CITY OF WICHITA

Wichita-Sedgwick County Metropolitan Area Planning Department

RE: **BZA2016-00035: City Sign Code Adjustment to increase square footage of sign on property zoned NR Neighborhood Retail.**

Legal Description: LOT 2, STEVENS-RYAN ADDITION, WICHITA, SEDGWICK COUNTY, KANSAS. Generally located east of South Seneca on the north side of West 29th Street South (1014 W. 29th Street S.)

SIGN 1 OPTION D

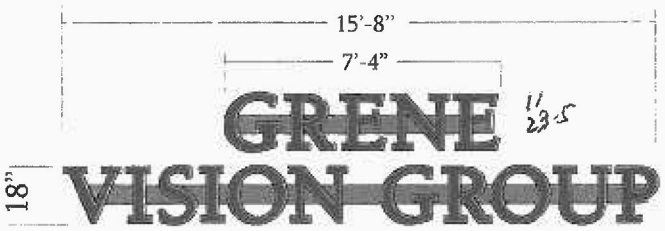
Our signatures below indicate that a Sign Code Adjustment to permit an adjustment to increase the size of the proposed sign to 36.3 square feet is **GRANTED**, subject to the following conditions:

1) The Administrative Adjustment is to allow a 36.3 square foot wall sign; all signage on the site shall otherwise conform to the Sign Code unless a separate adjustment or variance is approved.

2) The sign shall be in conformance with the approved elevation and site plan. The sign shall be permitted and installed within one year from the date of approval.
